82547GI/82547EI

Gigabit Ethernet Controller

Specification Update

June 23, 2006

PCN 104210-00

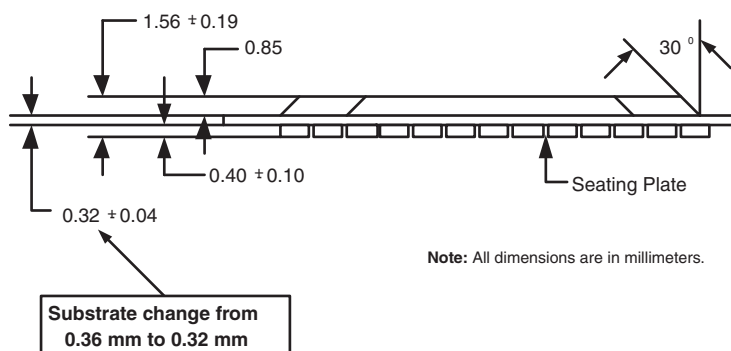
Implication: This migration allows flexibility with new substrate suppliers to support Intel demands on PBGA.

This migration does not affect fit, form, or function.
